Great North Road Solar and Biodiversity Park

Draft Statement of Common Ground with National Highways

Document Reference – EN010162/APP/8.4A

Revision number 2

Project:
**AADT CONSTRUCTION TRAFFIC FLOWS ON A1
 WORST CASE (100% Route North AND 100% Route South)**

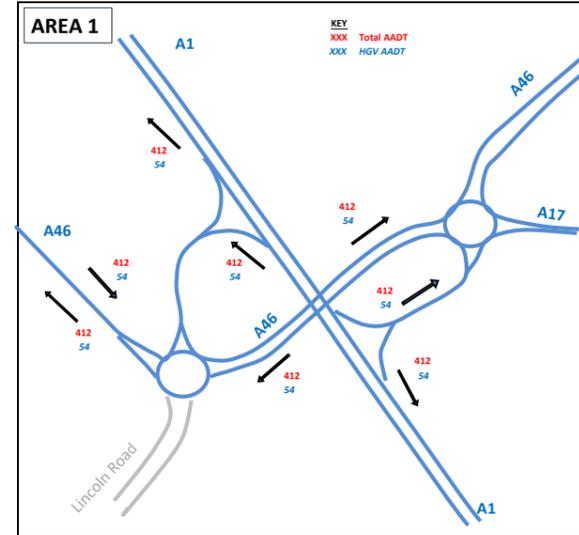
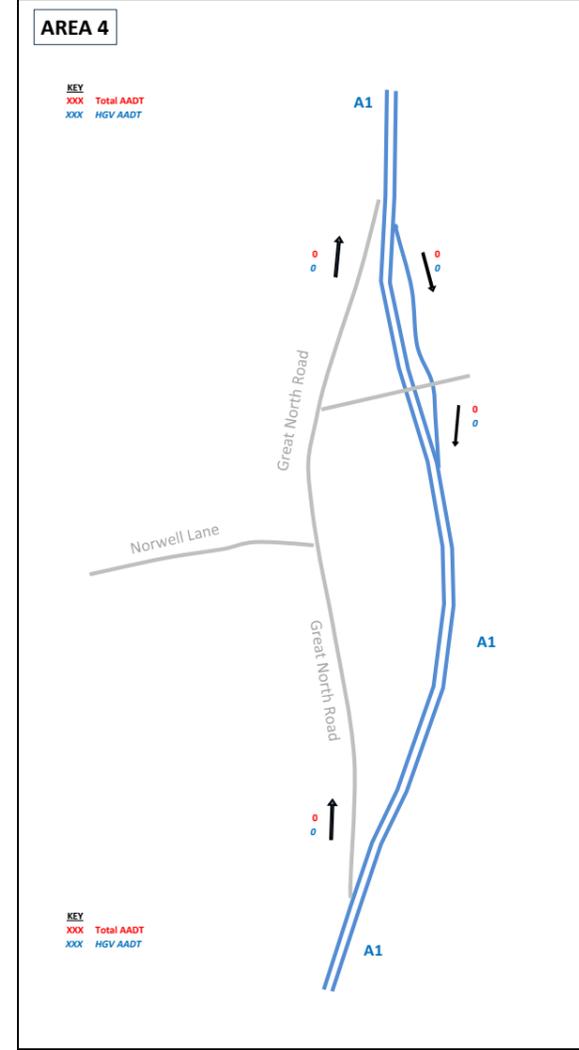
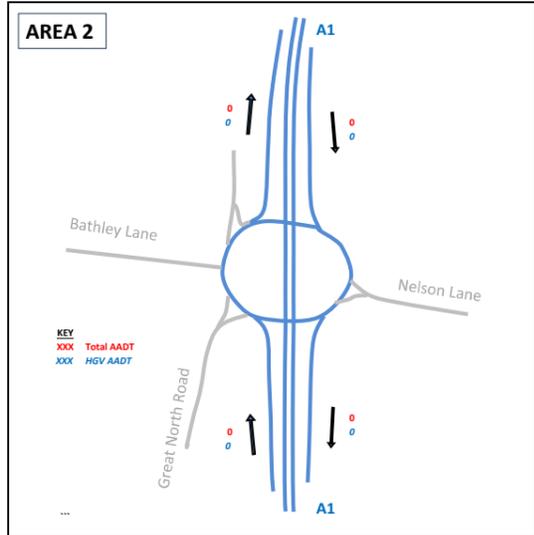
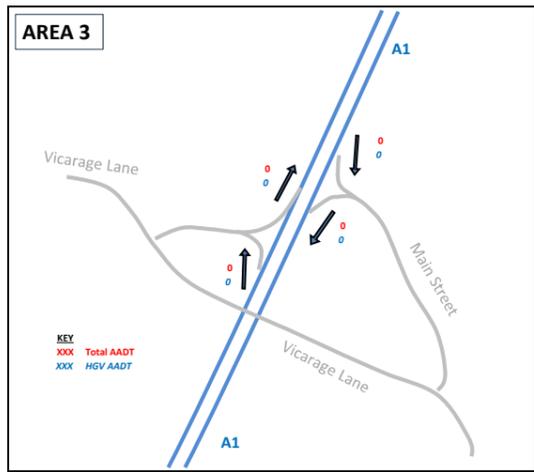
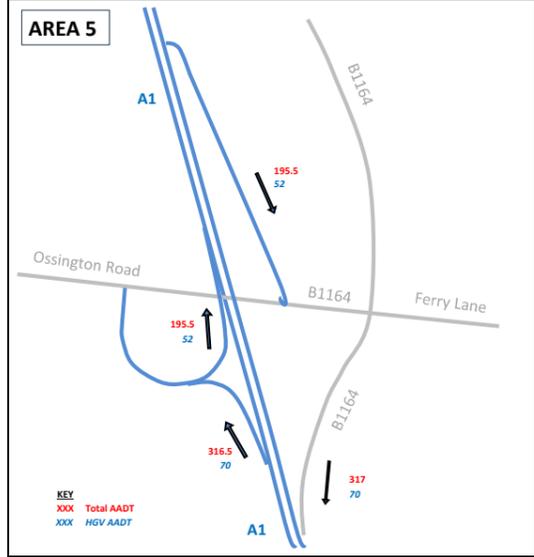
Month																									1	2	3	4	5	6	7	8	9	10	11	12	13	14	15	16	17	18	19	20	21	22	23	24	Trips on A1	0	12	20	26	6	10	10	11	11	11	7	4	1	16	28	36	8	12	13	13	13	13	10	6		
	Month																																																																															
	1	2	3	4	5	6	7	8	9	10	11	12	13	14	15	16	17	18	19	20	21	22	23	24																																																								
Trips on A1	0	12	20	26	6	10	10	11	11	11	7	4	1	16	28	36	8	12	13	13	13	13	10	6																																																								
2.1.5	WR	Trip Distribution	<p>Traffic flow diagrams for the junctions on the A1 were provided at Deadline 1. The flows presented are the AADT construction traffic flows on the A1, assuming a scenario whereby all traffic routes to/from the north and also, all traffic routes to/from the south. These</p>	National Highways requests that flow diagrams for construction traffic are provided for our review. When this	Under Discussion

Ref	Relevant Document	Description of Matter	Applicant's Position	National Highways' Position	Status
			diagrams will show the traffic flows currently presented in Appendix 1 of this SoCG.	has been provided, we will be in a better position to comment on the traffic impact of the proposed development.
